Re: NCIRT Review and USACE Approval of the Owls Den Draft Mitigation Plan; SAW 2013-00717;
EEP IMS #95808

SUBJECT: Owls Den- NCIRT Comments During 30-day Mitigation Plan Review

NCEEP Project Name: Owls Den Stream and Wetland Mitigation Site, Lincoln County, NC

Subject: Response to IRT Comments and Final Mitigation Plan Submittal
Owl's Den Stream and Wetland Mitigation Site, Lincoln County
Catawba River Basin – 03050102
HUC# 03050103 Expanded Service Area
EEP Project ID No. 95808 / USACE Action ID#2010-00717
Contract # 5150

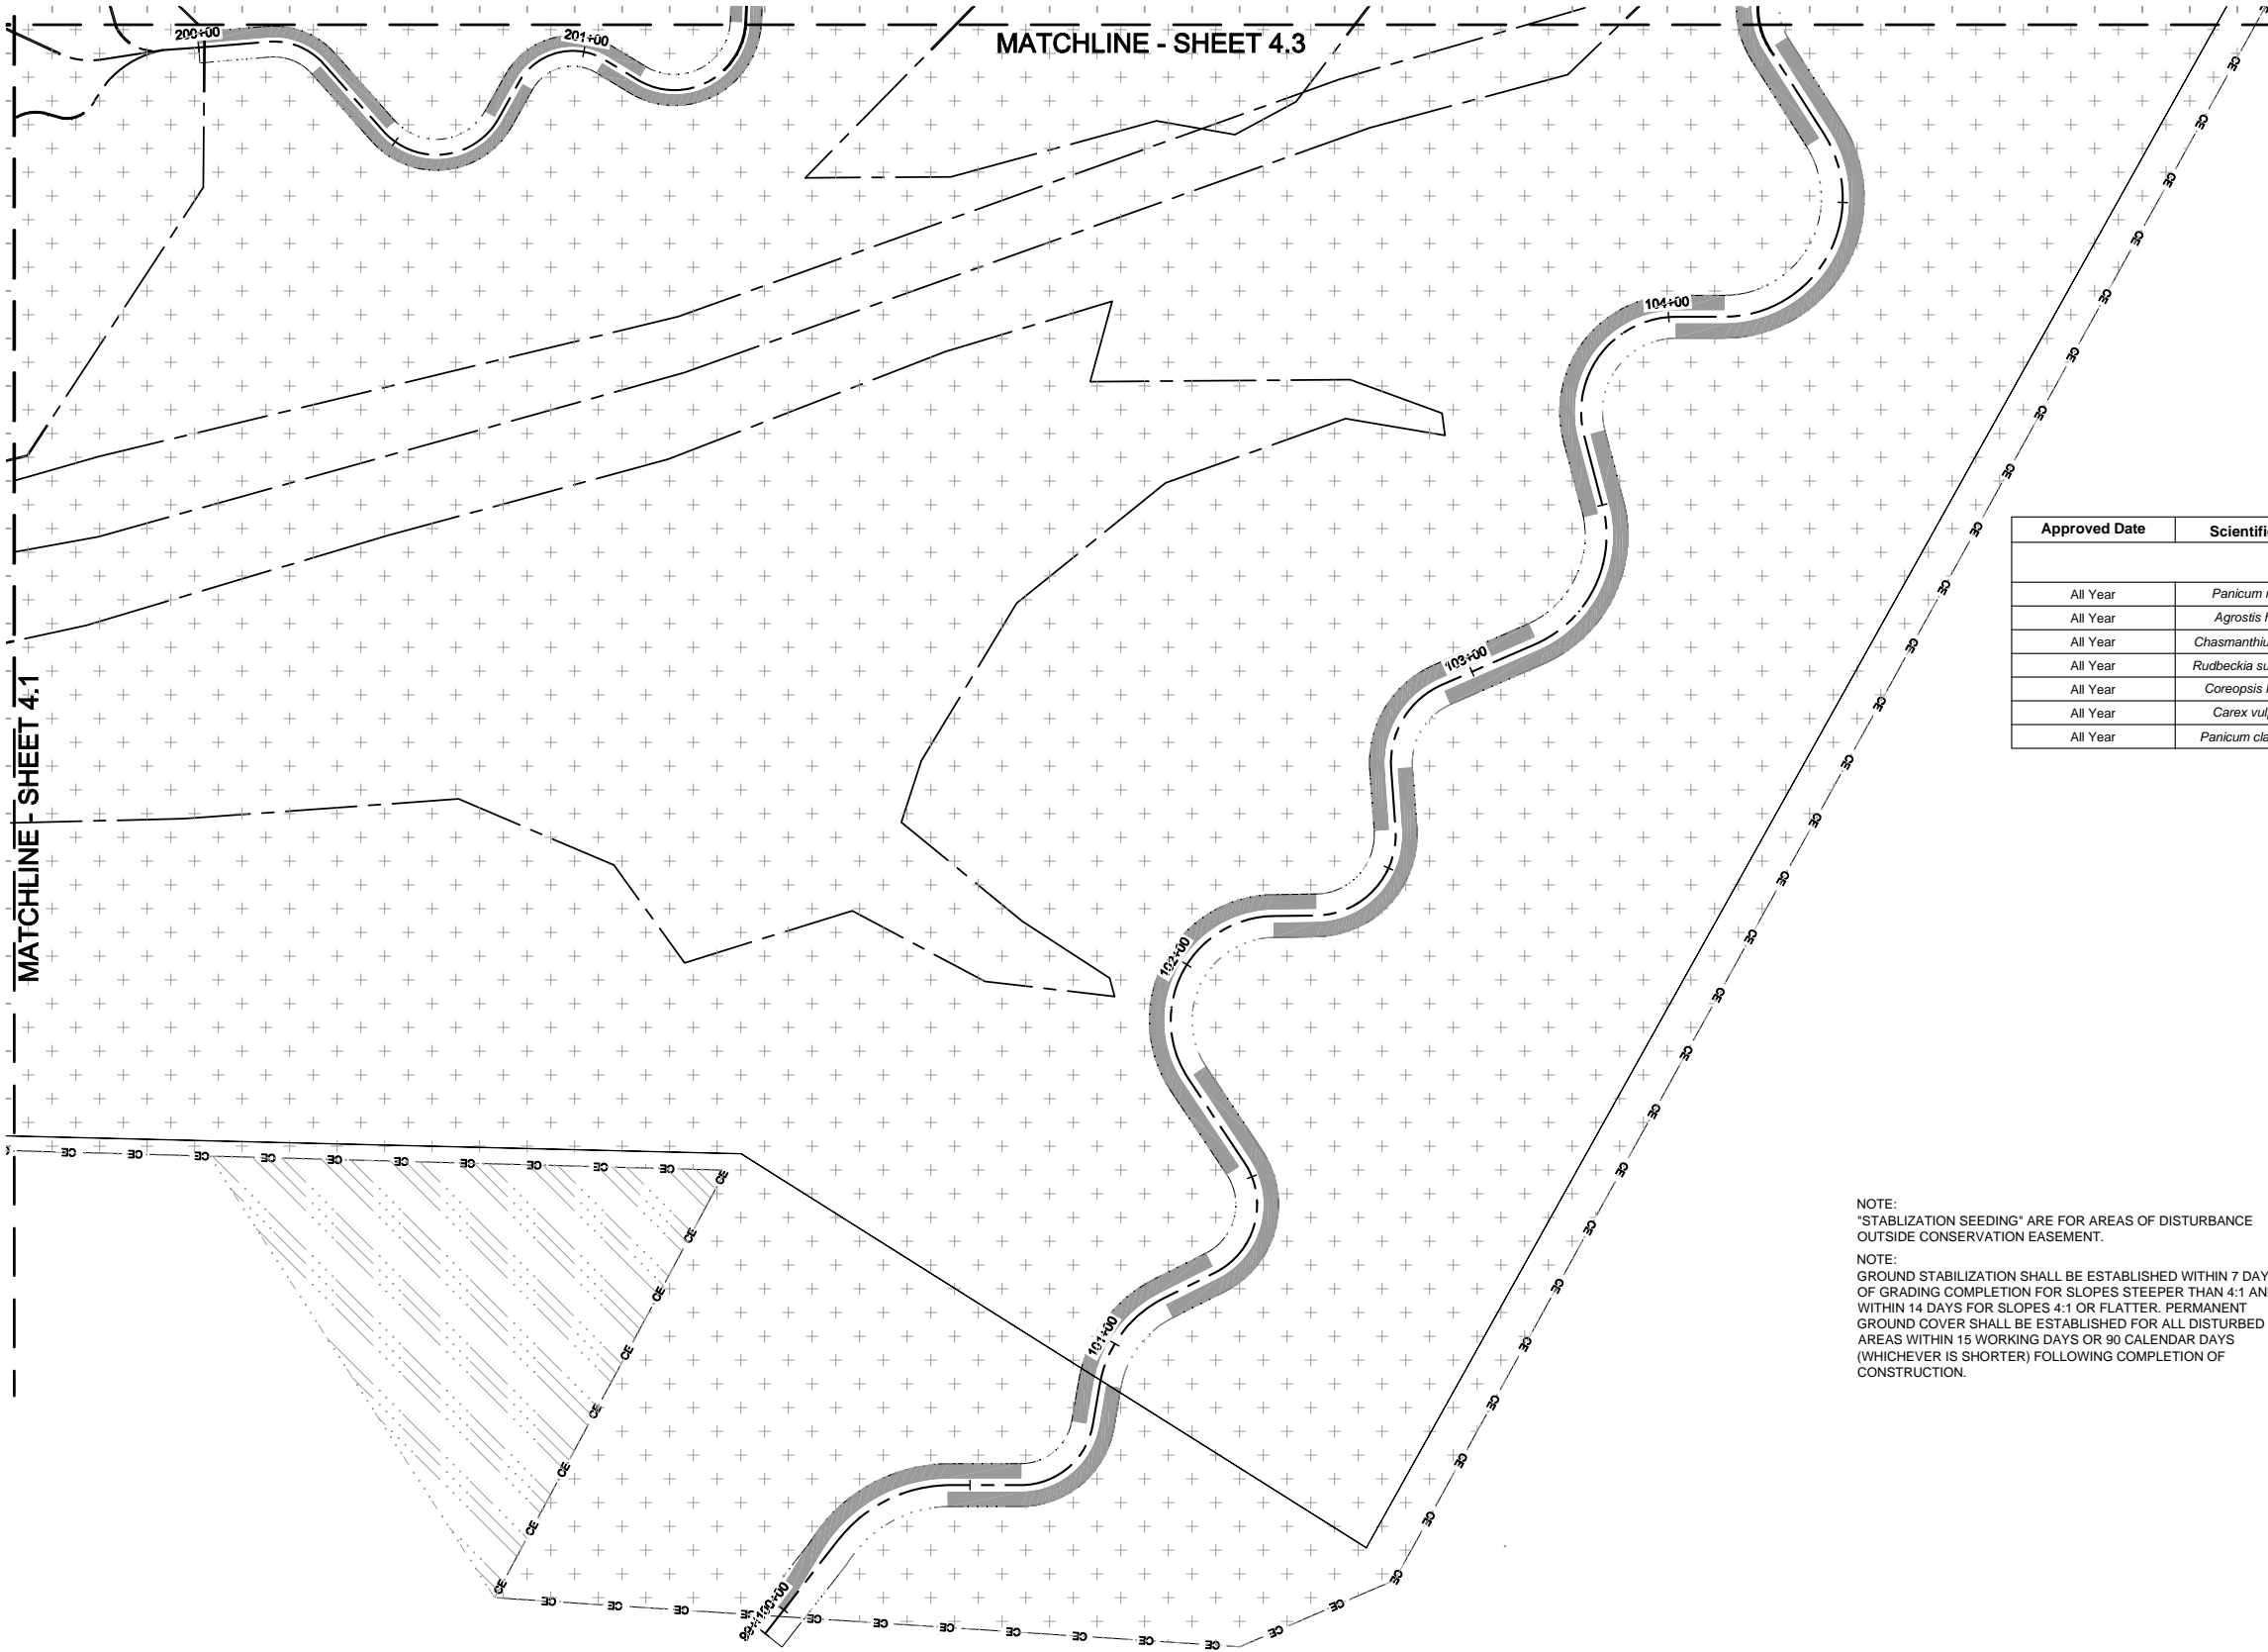
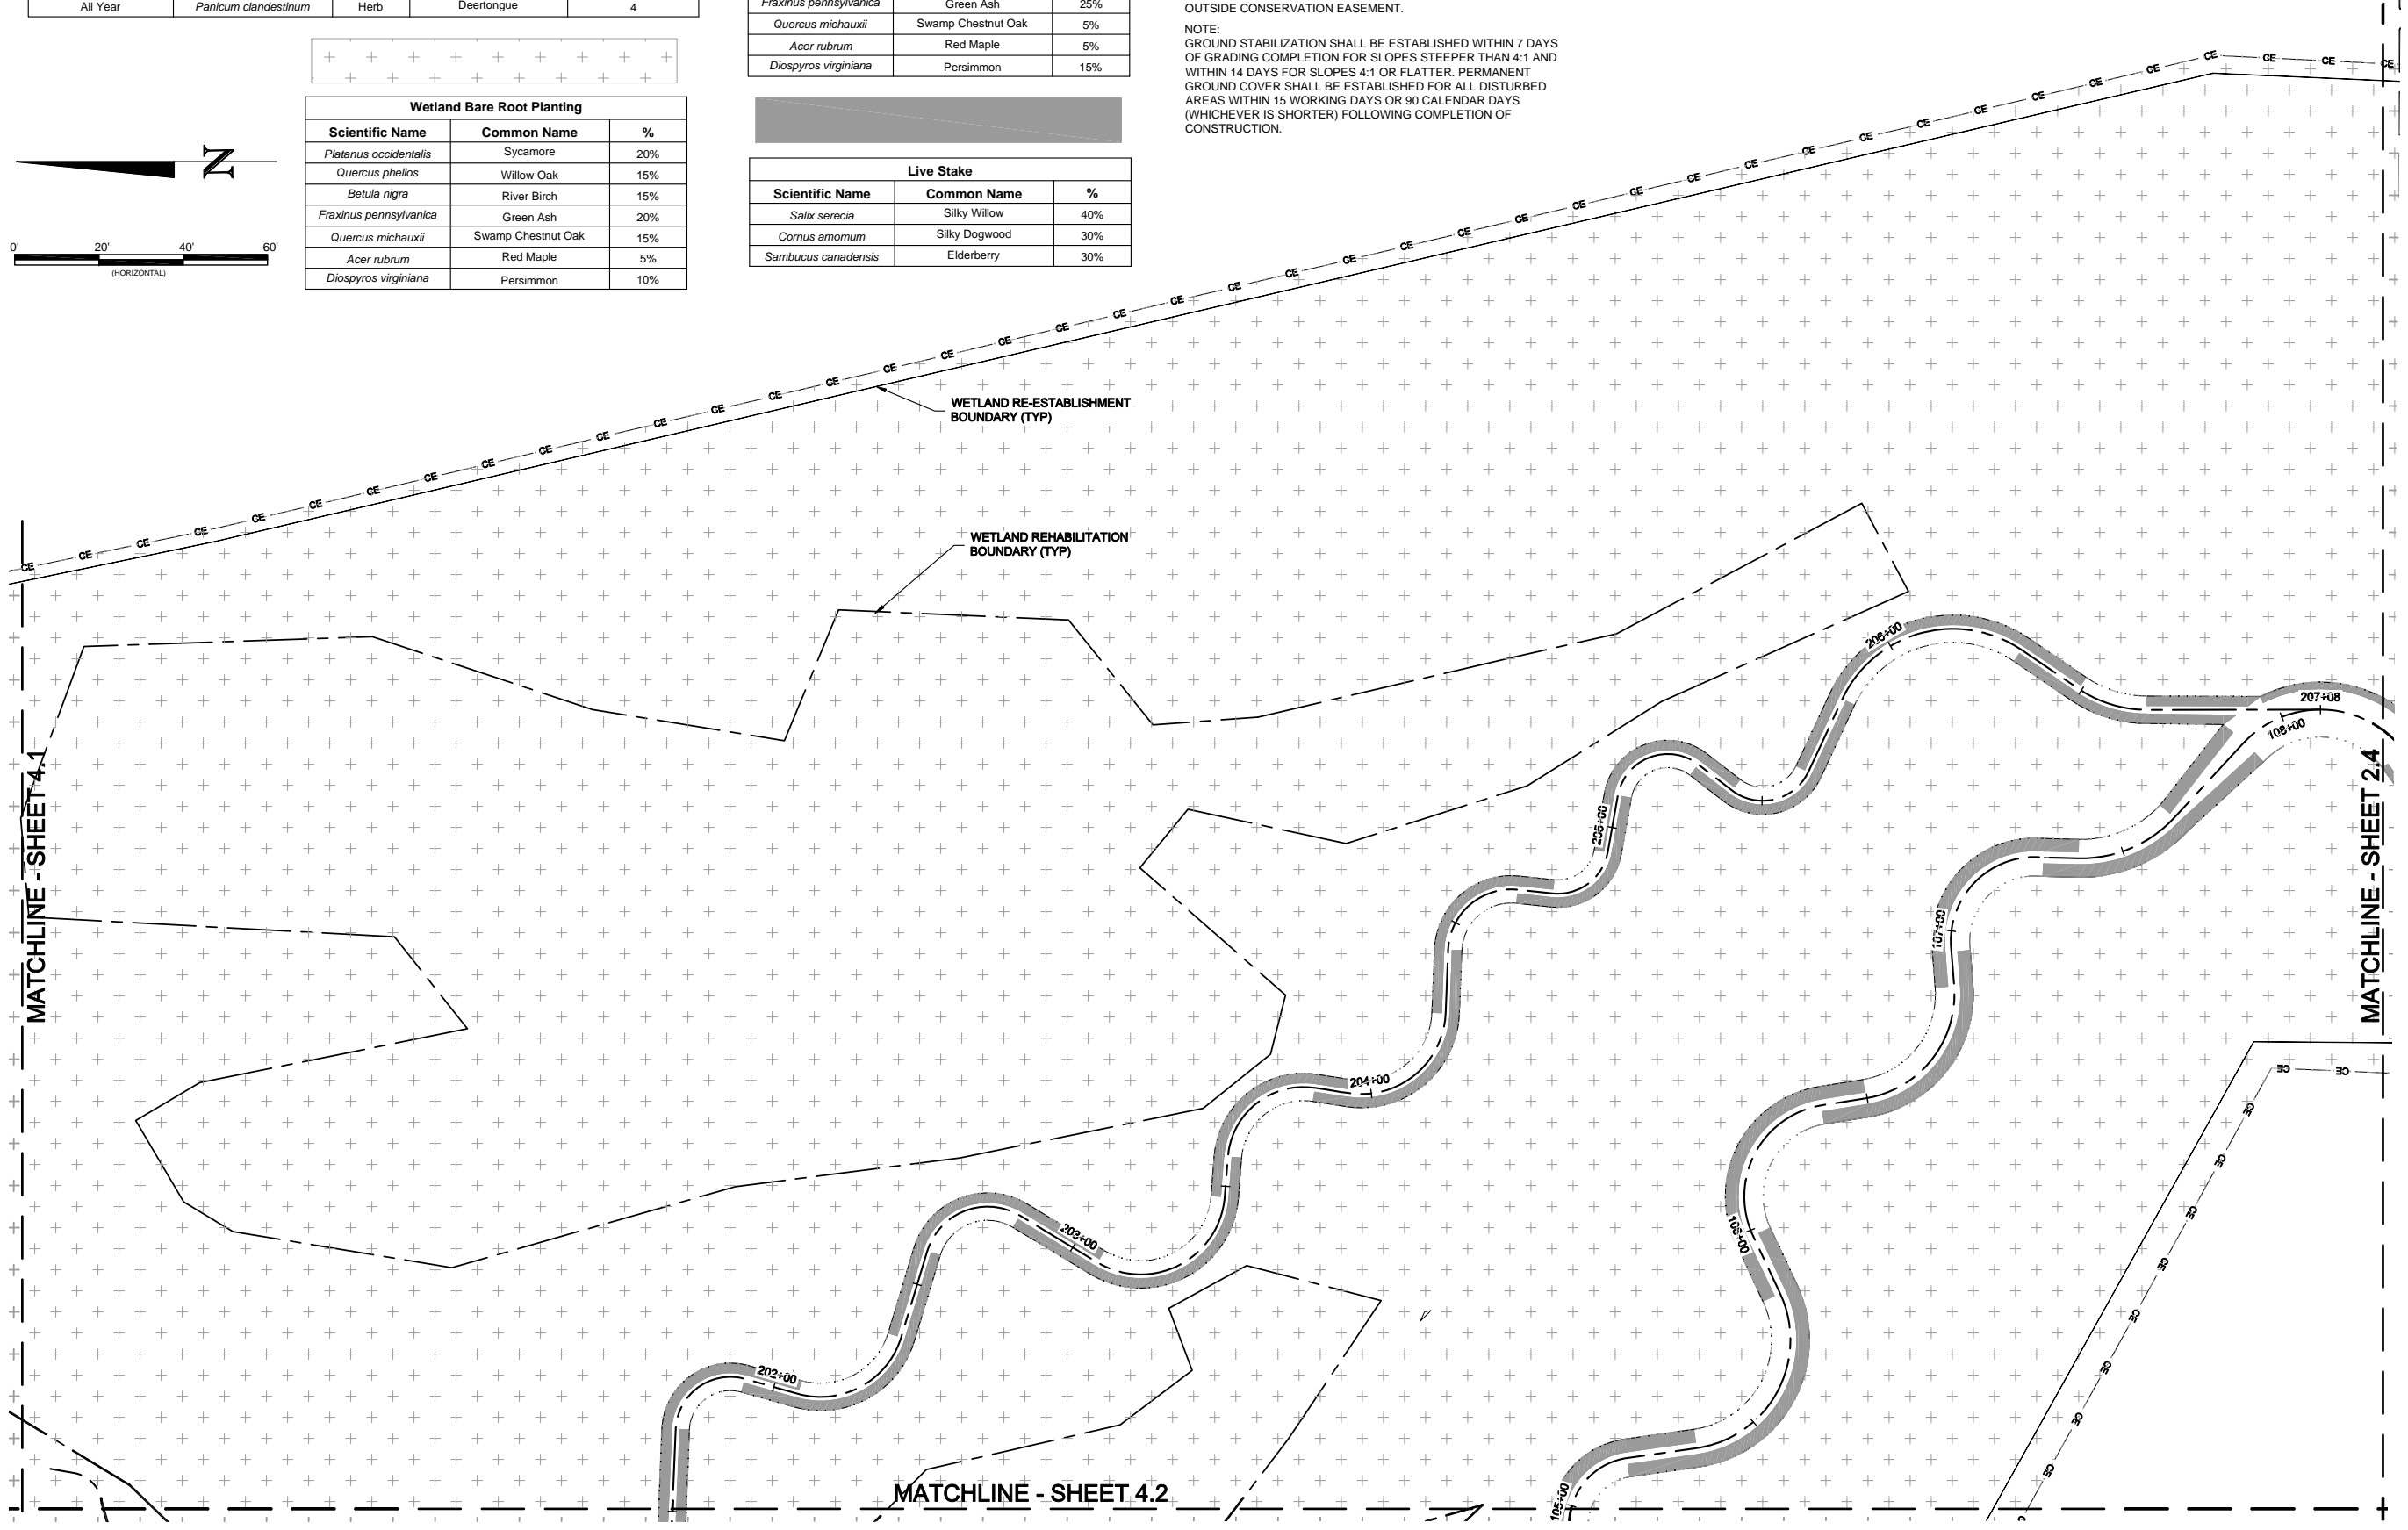
2. *The planting plan includes red maple. Red maple is a prolific volunteer species that has naturally established itself at most of the mitigation sites visited. Please omit this species from the planting plan, or at most, reduce it from 15% to 5% of the total planted stems.*

7. *Trees Planted: The assemblage of trees designated for wetland and riparian bare root planting (pages 345-9/Sheets 4.1-5) includes red maple (*Acer rubrum*) at 15%. I would recommend that if red maple needs to be included (and I don't think it does based on its ability to rapidly volunteer open sites) that its proportion be lessened to no more than 5% of all species planted.*

Red maple was reduced to 5% in the riparian and wetland bare root planting zones (Sheets 4.1 - 4.5). Sycamore and green ash species were increased to 25% of the riparian planted stems and 20% of the wetland planted stems.

Red maple was reduced to 5% in the riparian and wetland bare root planting zones (Sheets 4.1 - 4.5). Sycamore and green ash species were increased to 25% of the riparian planted stems and 20% of the wetland planted stems.
